## Memorandum

To: City of Gresham City Council  
From: Ray Moore, PE, PLS  
Date: 5-19-25  
Subject: Gresham Stormwater Management Manual Updates

## LOT LAYOUT SKETCH MAP

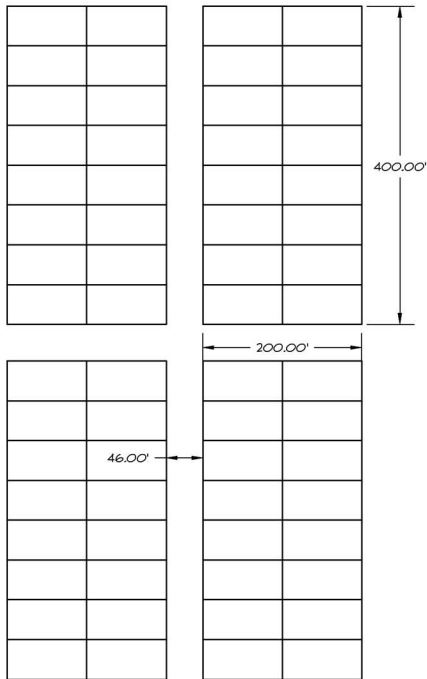
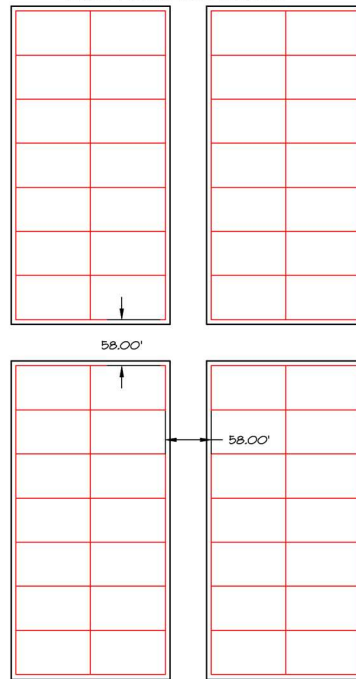
I am currently retrofitting subdivisions with 8' wide swales and can meet the water quality standards with this width. I think 10' wide swales would be overkill. I have also been placing the sidewalk in the general utility easement without making the right-of-way wider. See detail below. The swales are typically on streets that do not have driveways, so there is room to place the sidewalk in the easement without interfering with driveways. The current draft detail GS-115 shows a 10' swale between the sidewalk and the curb, the current code requires a minimum of 4'. This is an increase of 6' on each side of the street. So, the typical queuing street right of way will go from 46' to 58'. It is also my understanding that all street rights-of-ways will become wider with or without the installation of swales. This increase in right-of-way width will reduce densities. See the "Lot Layout Sketch Map" below. This is a rough map laying out 5,000 sf lots under the existing street widths and comparing them to the new right-of-way widths based on 10' wide swales. As you can see there is a 12.5% reduction in lots (8 lots removed). If the lots sold for \$150,000 each, this is a loss of \$1,200,000 just in land value. I recommend the following 1) Make the minimum width for new swales to be 8'. 2) Allow the sidewalks to be in an easement.

LAYOUT A WITH 8' SWALES IN EASEMENTS  
TOTAL LOTS = 64 LOTS

LAYOUT B WITH 10' SWALES IN ROW  
TOTAL LOTS = 56 LOTS  
(12.5% REDUCTION IN LOTS)
